Application No.: PL8335

| Record Type : | PLAT |

FINAL PLAT OF LOTS 43 AND 44, BLOCK D, LEXINGTON PLAZA

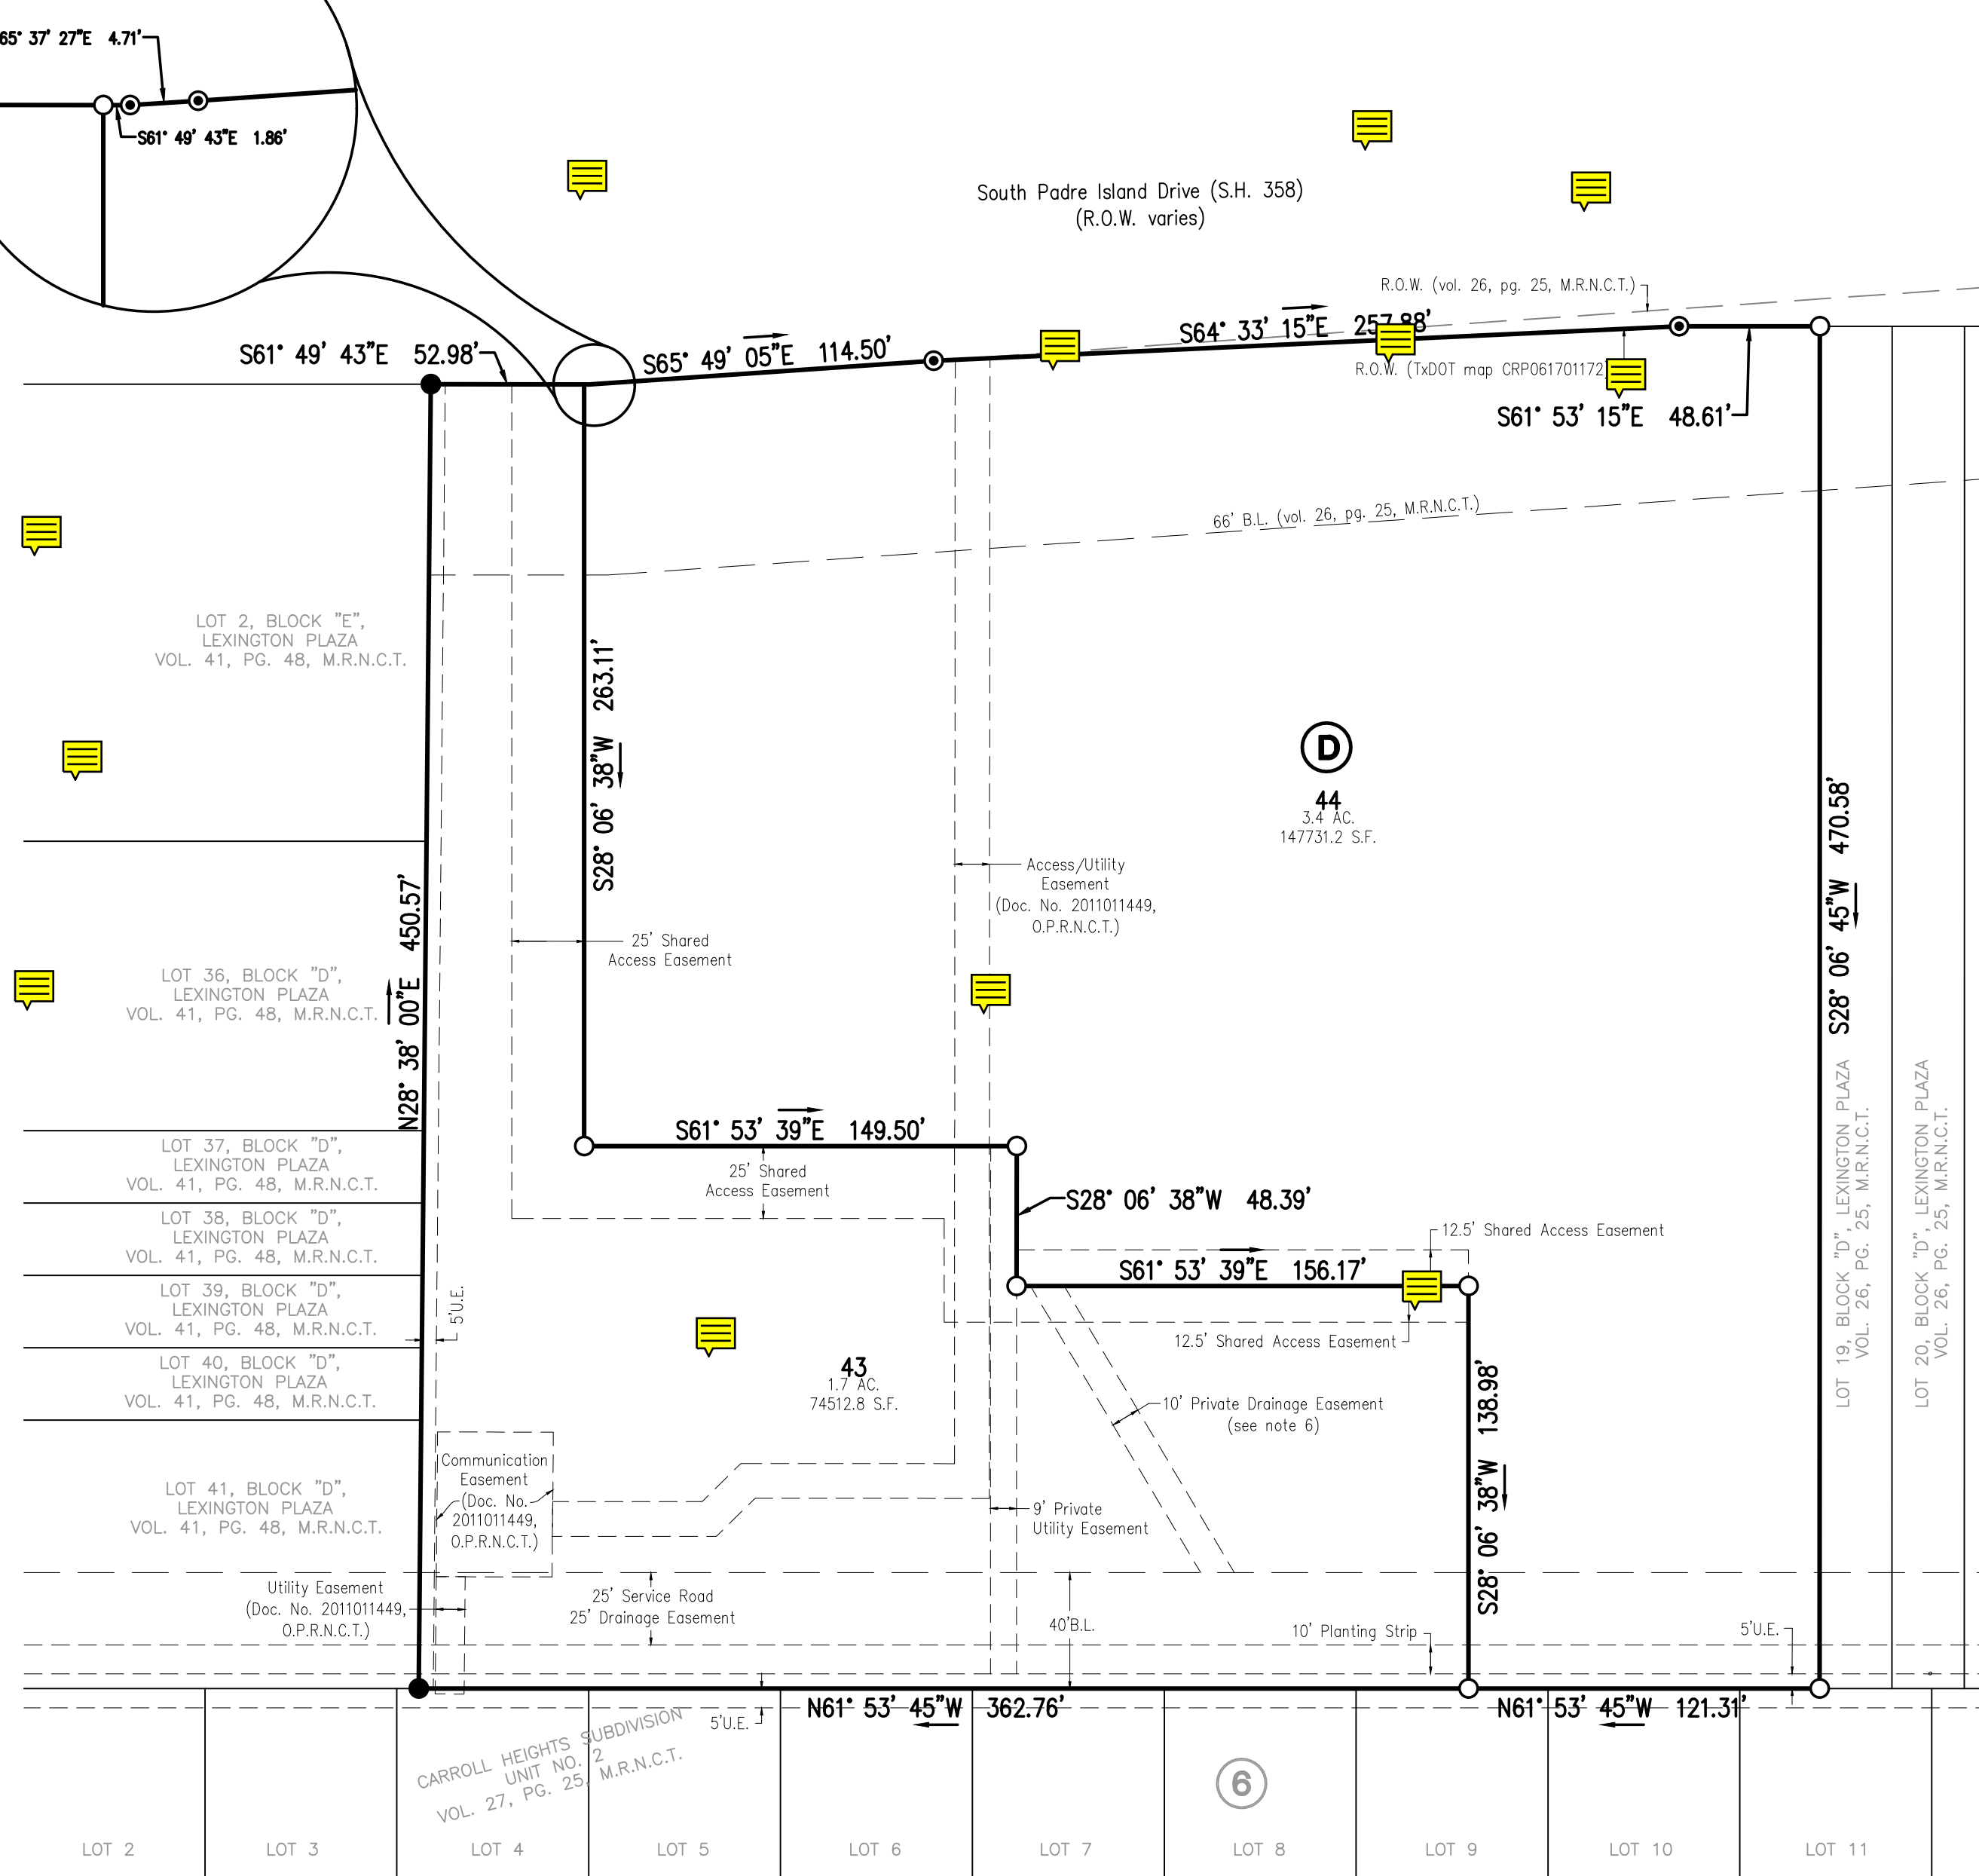
| Comment ID | Page Reference | Annotation Type | Author : Department | Status | Review Comments | Applicant Response Comments |
|------------|----------------|-----------------|---------------------|--------|---|-----------------------------|
| | | | | | <p>on this plat. However, some of the lot lines appear to go through the buildings. Please clarify the lot lines vs. buildings area.</p> <p>3 Infor. "Commercial Development shall have a fire flow of 1,500 GPM with 20 psi residual Fire hydrant every 300 feet and operational."</p> <p>4 Infor. 507.5.1 (amendment) Where Required: All premises, other than one-family detached dwellings, where buildings or portions of buildings are located more than 150 feet from a fire hydrant shall be provided with approved on-site hydrants and water mains capable of supplying the fire flow require by the fire official. The minimum arrangement being so as to have a hydrant available for distribution of hose to any portion of building on the premises at distances not exceeding 300 feet.</p> <p>5 Plat In referance to the above comment. Adding another access road to Caliber Collision will place the existing hydrant at a distance of approximately 670 ft. hose lay to the rear corner of the business. A hydrant will need to be added to reduce this distance to 300 ft.</p> <p>6 Plat 912.2.3 (amendment) Proximity to Hydrant: Fire department connections (FDC) for each sprinkler system or standpipe system shall be located not more than 100 feet from the nearest fire hydrant connected to an approved water</p> <p>7 Plat D102.1 Access and loading. Facilities, buildings, or portions of buildings hereafter constructed shall be accessible to fire department apparatus by way of an approved fire apparatus access road with an asphalt, concrete or other approved driving surface capable of supporting the imposed load of fire apparatus weighing at least 75,000 pounds.</p> <p>8 Infor. 503.1.1 (amendment) Buildings and facilities: During construction, when combustibles are brought on to the site in such quantities as deemed hazardous by the fire official, access roads and a suitable temporary supply of water acceptable the fire department shall be provided and maintained.</p> <p>9 Infor. 503.2.1 Dimensions. Fire apparatus access roads shall have an unobstructed width of not less than 20 feet, exclusive of shoulders and an unobstructed vertical clearance of not less than 13 feet 6 inches.</p> <p>10 Plat D103.1 Access road width with a hydrant. Where a fire hydrant is located on a fire apparatus access road, the minimum road width shall be 26feet, exclusive of shoulders.</p> | |

| Comment ID | Page Reference | Annotation Type | Author : Department | Status | Review Comments | Applicant Response Comments |
|------------|----------------|-----------------|---------------------|--------|---|-----------------------------|
| 2 | FINAL PLAT | Note | Mark Zans : DS | Closed | <p>Fire comments 11-15</p> <p>11 Infor. The minimum required width of 20 feet that shall be maintained means a clear unobstructed path that allows the passage of fire apparatus.</p> <p>1. Where Fire Apparatus Access is constructed to the minimum of 20 feet, no parking is allowed within the fire apparatus lane.</p> <p>2. Where a fire hydrant is located on the street, the minimum unobstructed clearance shall be 26 feet. In this instance, no parking is allowed on one side of the street.</p> <p>3. The minimum UDC residential street width is 28 ft. curb to curb. Any parking along the street that reduces the width to less than 20 ft. is prohibited and the Fire Code Official and will require painting "NO PARKING-FIRE LANE" along one side of the street."</p> <p>12 Plat Note: Calculated Turning Radii for Fire Apparatus: Inside Turn: 20 ft. 3 in. Curb to curb: 36 ft. 8 in. Wall to wall: 44 ft. 8 in."</p> <p>13 Infor. 503.3 Marking: Where required by the fire code official, approved signs, or other approved notices the include the words NO PARKING-FIRE LANE shall be provided for fire apparatus access roads to identify such roads to prohibit the obstruction thereof. The designation of a fire lane can be marked with conspicuous signs which have the words: " Fire Lane-No Parking" at 50-foot intervals. In lieu of signs, fire lanes may be marked along curbing with the wording, "Fire Lane-No Parking" at 15-foot intervals.</p> <p>14 Infor. 503.2.5 Dead ends. Dead-end fire apparatus access roads more than 150 feet in length shall be provided with an approved area for turning around fire apparatus.</p> <p>15 Infor. Commercial development of the property or change of occupancy use will require further Development Services review.</p> | |

| Comment ID | Page Reference | Annotation Type | Author : Department | Status | Review Comments | Applicant Response Comments |
|------------|----------------|-----------------|----------------------|--------|---|-----------------------------|
| 7 | FINAL PLAT | Note | Mark Zans : DS | Closed | <p>TxDot comments- Place as general notes on the plat.</p> <ul style="list-style-type: none"> • No increase in storm water discharge to State right-of-way shall be accepted by TxDOT. • TxDOT Permits will be issued in accordance with the access management standards and all applicable state and federal laws, including rules and regulations. Access connection spacing, materials, geometrics, accessibility, and other design specifications will be considered, as well as the impact on drainage and hydraulics, utility location or relocation, and the environment that will result from the requested construction of an access connection. 43 Tex. Admin. Code § 11.52 (2020). • Drainage improvements shall accommodate runoff from the upstream drainage area in its anticipated maximum "build-out" or "fully developed" condition, and shall be designed to prevent overloading the capacity of the downstream drainage system • If the owner responsible for maintenance of the permanent stormwater or water quality control fails to maintain the control to TXDOT ROW, the owner shall correct the problem | |
| 10 | FINAL PLAT | Note | Melanie Barrera : DS | Closed | place plat note (not just on SWQMP, on plat as well) that any increase to stormwater runoff flow rates shall be mitigated to comply with UDC 8.2.A, 8.2.8.B., and IDM 3.05 | |
| 11 | FINAL PLAT | Note | Mark Zans : DS | Closed | AEP Distribution- Requesting that electrical distribution elements be encompassed in an electrical easement and labeled on the plat. | |
| 12 | FINAL PLAT | Note | Mark Zans : DS | Closed | Are notes 6 and 7 for the same easement? | |
| 13 | FINAL PLAT | Note | Mark Zans : DS | Closed | Please correct the plat title to read Lexington Plaza Block D Lots 43 and 44 | |
| 17 | FINAL PLAT | Note | Mark Zans : DS | Closed | Why are lot lines cutting through buildings? | |

| Comment ID | Page Reference | Annotation Type | Author : Department | Status | Review Comments | Applicant Response Comments |
|------------|----------------------------------|-----------------|-----------------------|--------|---|-----------------------------|
| 19 | FINAL PLAT | Note | Mark Zans : DS | Closed | <p>traffic comments-</p> <p>1 Plat Provide 25 foot shared access easement at location of current functional access aligning with current Access/Utility Easment (Doc 2011011449)</p> <p>2 Informational The lot configuration as shown appears to assume an additional driveway to the northwest corner of the property. This would have to be approved as an additional driveway by TxDOT. In addition, this would necessitate site work to be operational. Comment 1 addresses current operations that do not necessitate TXDOT permit nor site work.</p> | |
| 20 | FINAL PLAT | Note | Mark Zans : DS | Closed | <p>GIS comments</p> <p>1. Please confirm that plat closes to standards.</p> <p>2. Are plat lines cutting through buildings?</p> <p>3. Provide volume and page numbers for easements.</p> | |

STORM WATER QUALITY
MANAGEMENT PLAN
FOR
LOT 43 AND LOT 44, BLOCK D,
LEXINGTON PLAZA

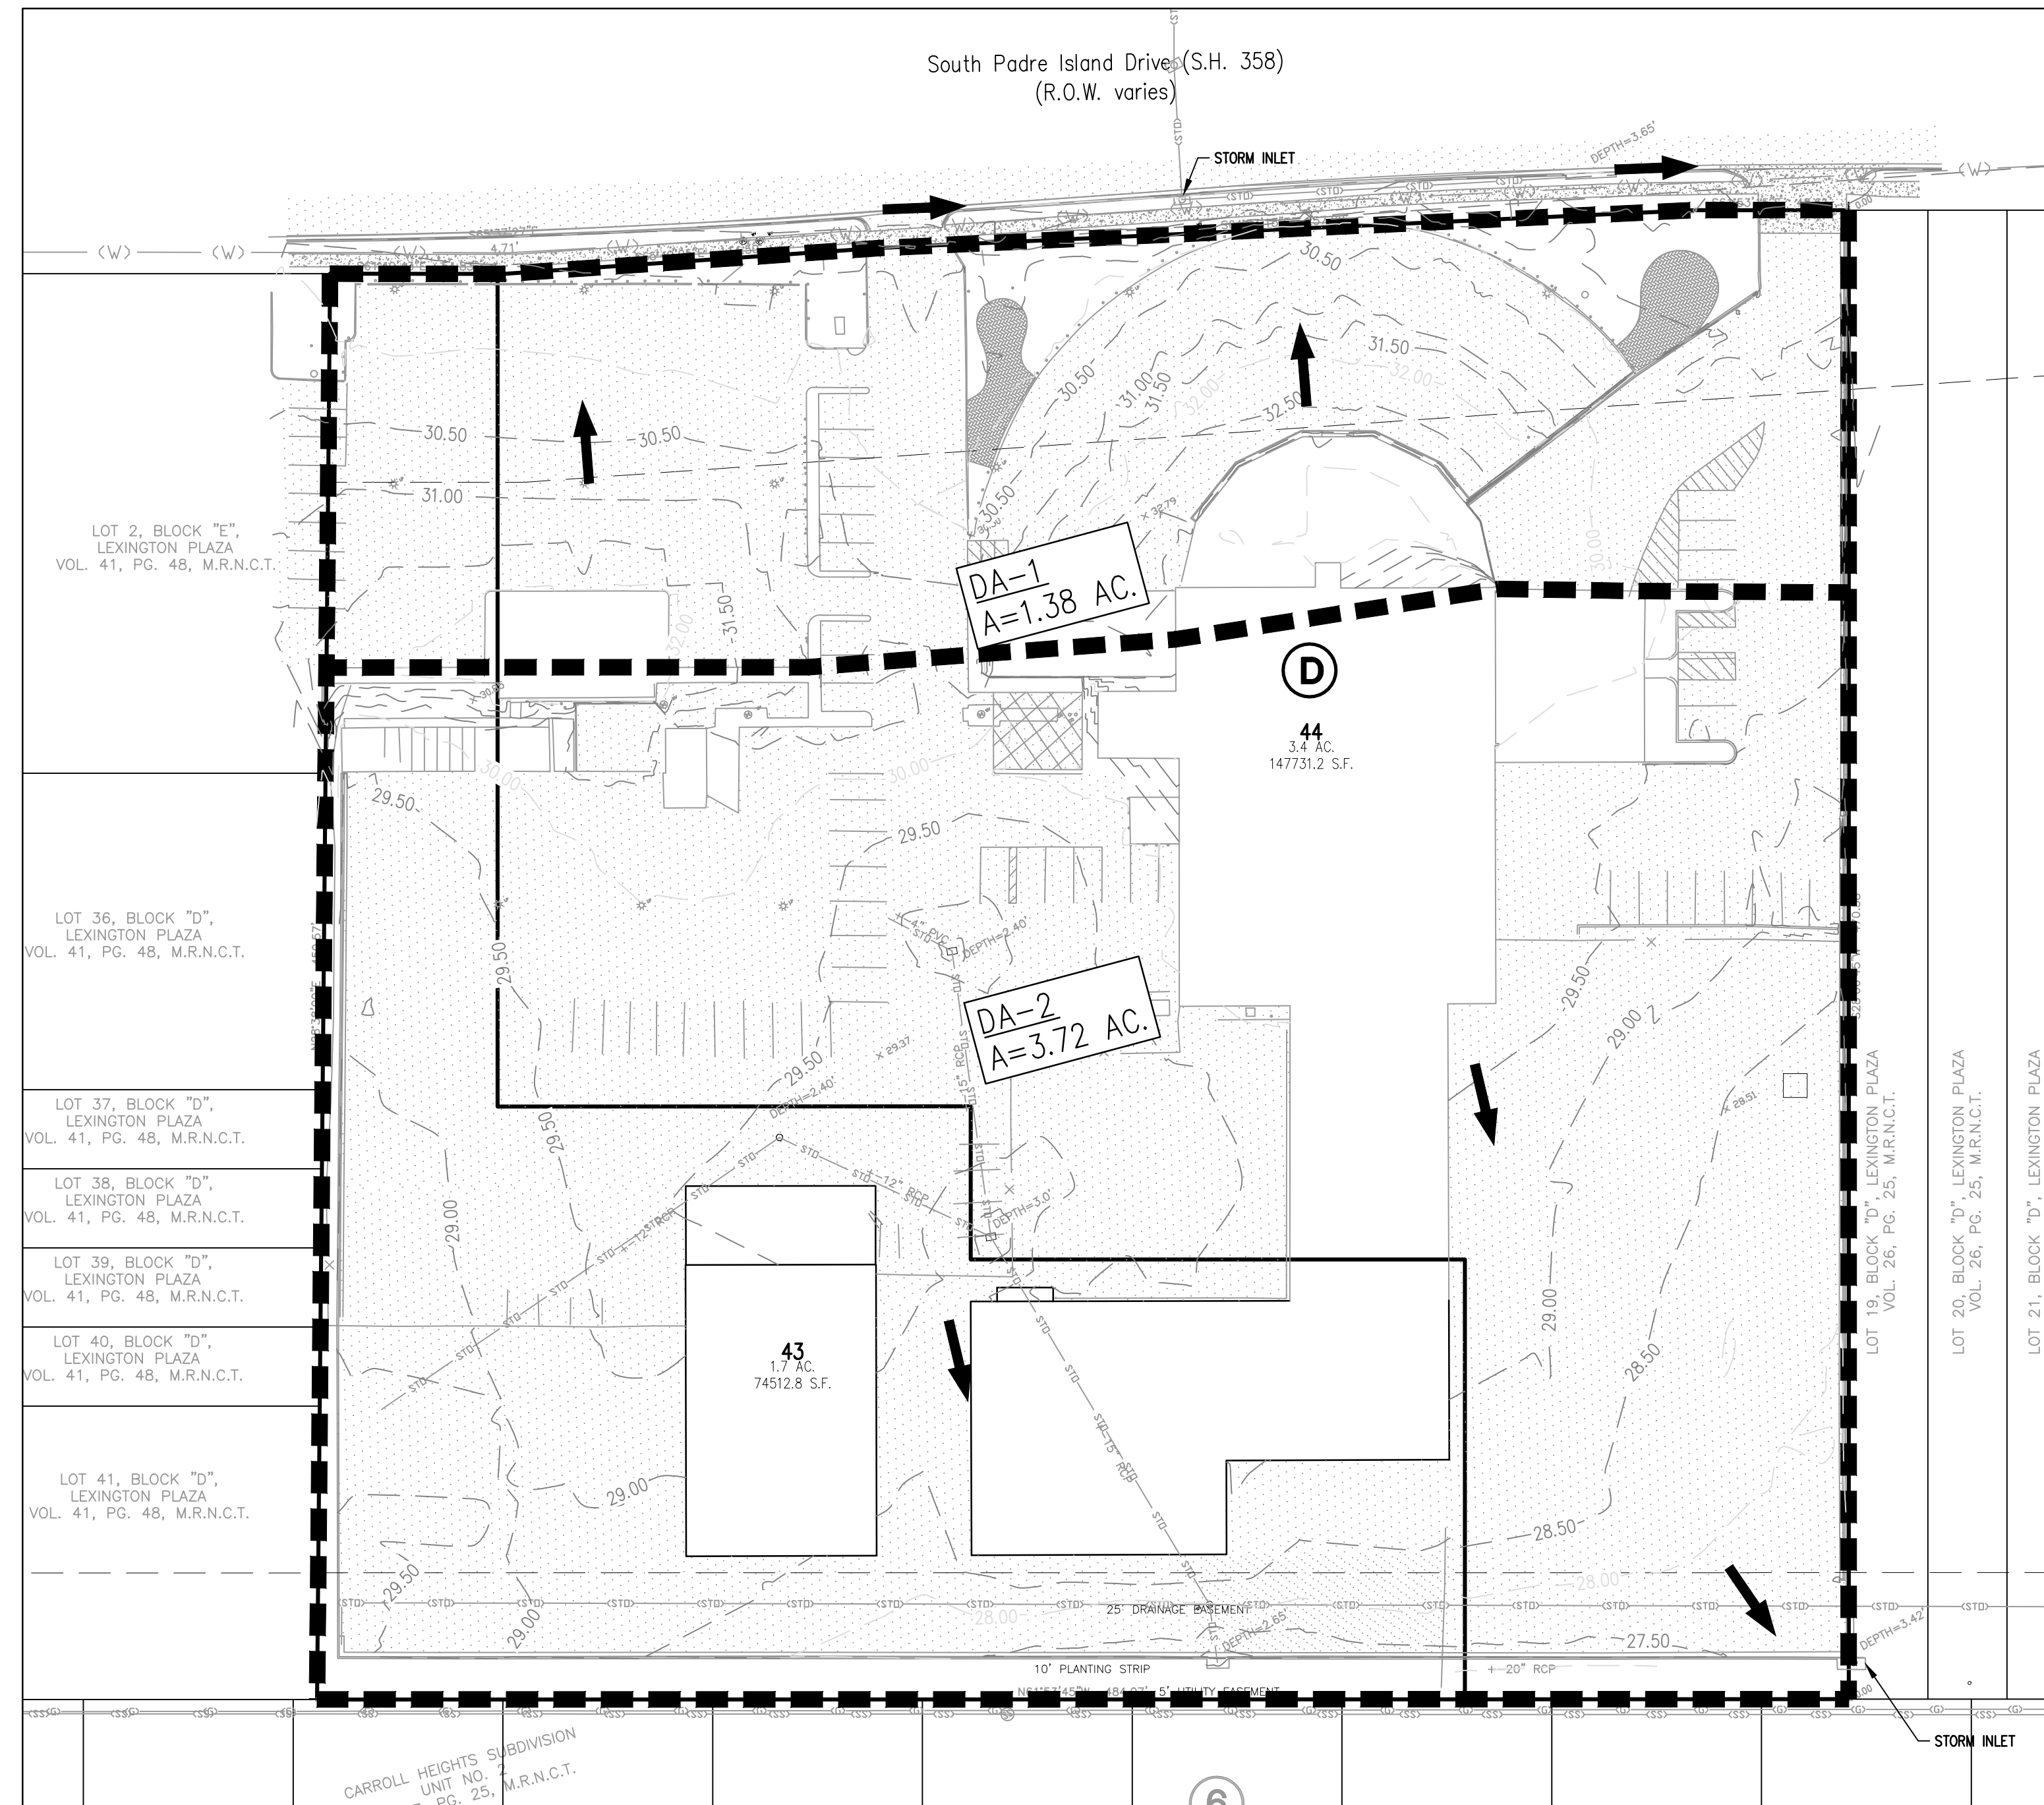
| Comment ID | Page Reference | Annotation Type | Author : Department | Status | Review Comments | Applicant Response Comments |
|------------|----------------------------------|-----------------|-----------------------|--------|---|-----------------------------|
| 15 | 10062301-SWQMP-204 DRAINAGE PLAN | Note | Melanie Barrera : DS | Closed | further review to occur prior to site development/change in impervious surface | |
